**City of Ketchum  
Planning & Building**

**STAFF REPORT  
KETCHUM PLANNING AND ZONING COMMISSION  
REGULAR MEETING OF JUNE 13, 2023**

- PROJECT:** Miller Residence
- FILE NUMBER:** P22-046 and P22-046A
- APPLICATION TYPE:** Mountain Overlay Design Review and Conditional Use Permit
- REPRESENTATIVE:** Aaron Bunse – Studio DVLP, LLC (architect)

- PROPERTY OWNER:** Paramount Property Development LLC
- REQUEST:** Mountain Overlay Design Review application for the development of a new 3,745 square foot single-family residence. A Conditional Use Permit application is also requested for the avalanche retaining wall located at the rear of the proposed residence.

Figure 2: Project's Roof

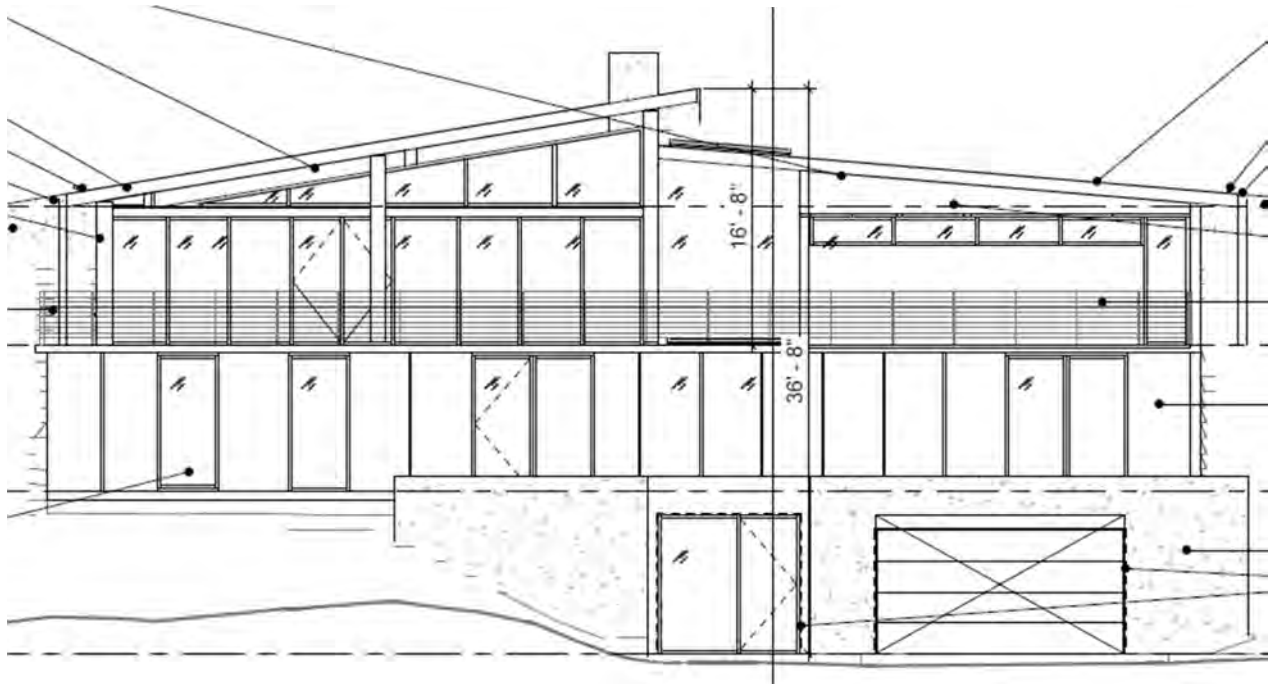
and features a Santa Fe architectural style which has flat roofs with stucco and block forms. The structure to the lookers left is one story in height with pitched roofs and stucco and stone siding. The architectural style of the proposed residence is modern in nature; however, it is complementary of the newer and older residences of the neighborhood as it utilizes wood and steel siding, board formed concrete, large windows, and shed roofs sloped away from each other which presents as a pitched roof. Please see Figure 2 below for details on the proposed roof for the structure. Additionally, pursuant to KMC §17.96.060.F.2 & 5, “The building character shall be clearly defined by the use of architectural features” and “Buildings walls shall provide undulation/relief, thus reducing the appearance of bulk and flatness.” The proposed residence is three stories in height and each floor of the structure is stepped back into the hillside, providing undulation and relief to reduce the appearance of bulk and flatness.

Figure 3: Project's Front Lot Lines and Front Setback

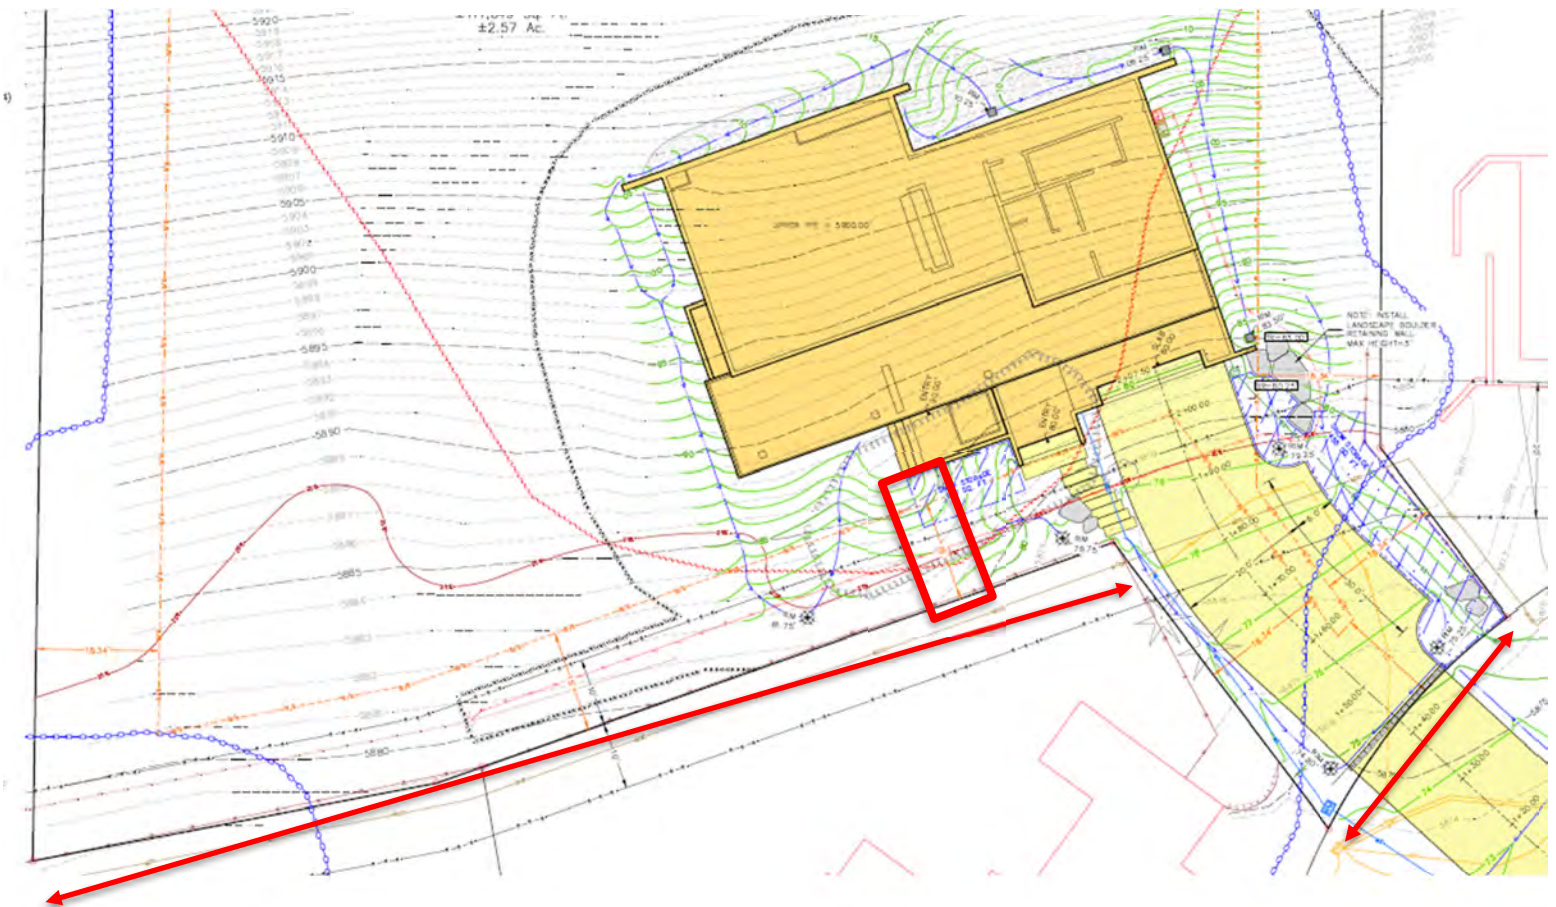
The KMC defines minimum setbacks for the front, side, and rear lot lines for each project. The KMC defines the "lot line, front" as "The property line dividing a lot from a street. On a corner lot, only one street line shall be considered as a front line, and the shorter street frontage shall be considered the front line, unless otherwise determined by the administrator based on the orientation and layout of the lot and surrounding neighborhood." There are two front lot lines for the subject property. The lot is situated behind two existing single-family homes and is uniquely shaped with a narrow entrance between the two lots to access the subject property. The proposed residence is setback 15 feet from the longer of the two front lot lines, which is setback at the lowest possible elevation. Please see Figure 3 below which outlines the two front lot lines and front yard setback in red.

A SITE GRADING, R.O.W. ENCROACHMENT, & UTILITY PLAN SHOWING  
 LOT 9, BLK 5, WARM SPRINGS VALLEY SUBDIVISION  
 WITHIN S11, T.4N., R.17E., B.M., CITY OF KETCHUM, BLAINE COUNTY, IDAHO  
 PREPARED FOR PARAMOUNT PROPERTY DEVELOPMENT LLC

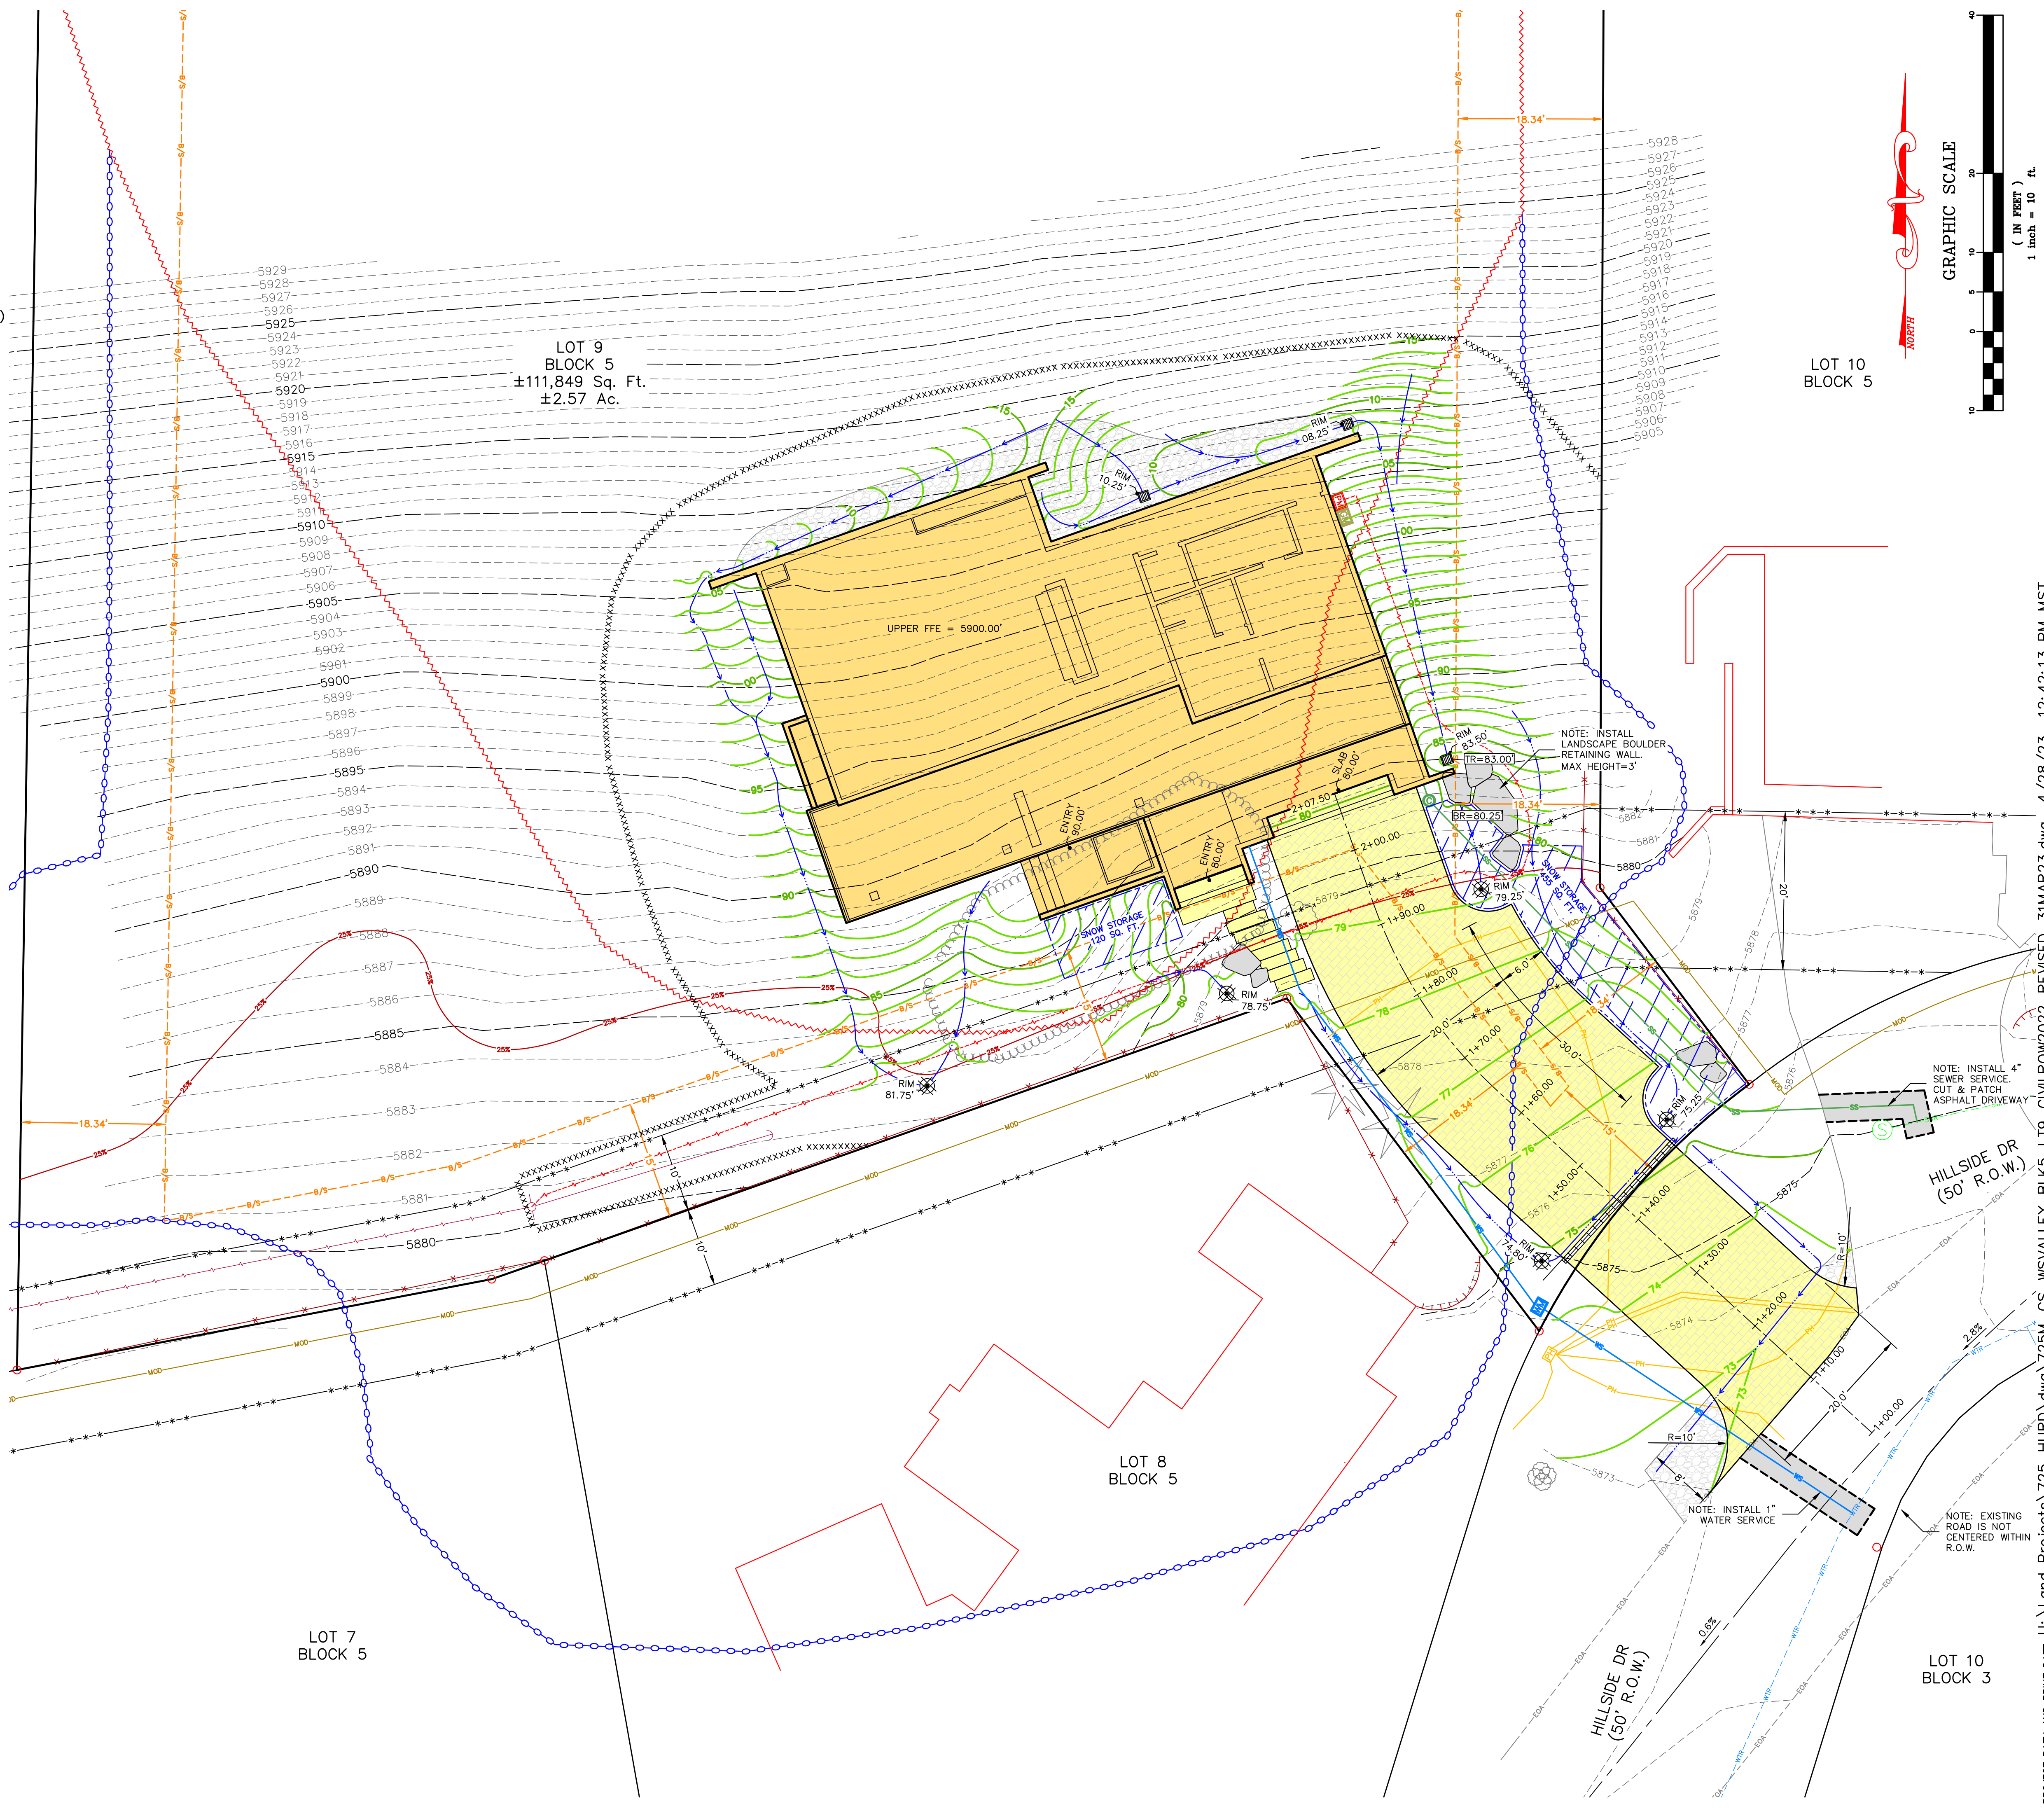
17.96.060.D.2 - Utilities	Conformance
<i>Utilities shall be located underground and utility, power, and communication lines within the development site shall be concealed from public view.</i>	YES
<p><b>Finding:</b> As shown on Sheet C1.0 of the project plans, the applicant has proposed connecting to the municipal water and sewer systems from existing lines on Hillside Drive. Requirements and specification for the water and sewer connections will be verified, reviewed, and approved by the Utilities Department prior to issuance of a Building Permit for the project.</p>

17.96.060.H.1 – Snow Storage	Conformance
<i>Snow storage areas shall not be less than 30 percent of the improved parking and pedestrian circulation areas.</i>	YES
<b>Finding:</b> Sheets C1.0 & C2.0 show the proposed snow storage areas to include 575 square feet, greater than the required 30% (1,825 * .30 = 547 square feet).

17.96.060.H.2 – Snow Storage	Conformance
<i>Snow storage areas shall be provided on site.</i>	YES
<b>Finding:</b> Sheet C1.0 shows the snow storage areas to be provided are on-site.

17.96.060.H.3 – Snow Storage	Conformance
<i>A designated snow storage area shall not have any dimension less than five feet and shall be a minimum of 25 square feet.</i>	YES
<b>Finding:</b> Sheet C1.0 shows that no snow storage area has dimensions less than five feet.

<input checked="" type="checkbox"/>	<input type="checkbox"/>	<input type="checkbox"/>	<b>17.104.070.A.7</b>	<b>Public water and sewer service comply with the requirements of the City.</b>
			<b>Findings</b>	As shown on C1.0 of the project plans, the applicant is proposing to connect to the municipal water and sewer systems from existing lines within Hillside Drive. Requirements and specification for the water and sewer connections will be verified, reviewed, and approved by the Utilities Departments prior to issuance of a Building Permit for the project.
<input checked="" type="checkbox"/>	<input type="checkbox"/>	<input type="checkbox"/>	<b>17.104.070.A.8</b>	<b>Drainage is controlled and maintained to not adversely affect other properties.</b>
			<b>Findings</b>	Pursuant to KMC §17.96.060.C.1, all storm water drainage shall be retained on site. Drainage improvements are specified on Sheet C1.0 of the project plans in Attachment B. The drainage improvements include the installation of a trench drain bordering the length of the driveway. A combination of drywells and catch basins will be installed to collect stormwater from the rest of the property. The City Engineer has reviewed the proposed drainage plan and believes the trench drain and drywell improvements are sufficient to maintain all storm water drainage on-site.  All drainage plans and specifications shall be reviewed and approved by the City Engineer and Streets Department prior to issuance of a Building Permit for the project.

<input checked="" type="checkbox"/>	<input type="checkbox"/>	<input type="checkbox"/>	<b>17.104.070.A.12</b>	<b>Utilities shall be underground.</b>
			<b>Findings</b>	The utility improvements are indicated on Sheet C1.0 of the project plans. The project will utilize sewer, gas, and electrical service from Hillside Drive. The Utilities Department reviewed the project plans and the service connections for compliance with city requirements. Pursuant

to condition of approval #2, the applicant shall submit final civil drawings prepared by an engineer registered in the State of Idaho that provide specifications for the proposed utility improvements for final review and approval by the Utilities Department prior to issuance of a building permit for the project.
<input checked="" type="checkbox"/>	<input type="checkbox"/>	<input type="checkbox"/>	17.104.070.A.13	<b>Limits of disturbance shall be established on the plans and protected by fencing on the site for the duration of construction.</b>
			Findings	Sheet C1.0 shows the proposed limits of disturbance on the subject property for the proposed residence. A construction management plan that addresses all construction activity standards specified in Ketchum Municipal Code §15.06.030 will be required to be submitted with the building permit application. City Departments will conduct a comprehensive review of the proposed construction management plan during plan review for the building permit.
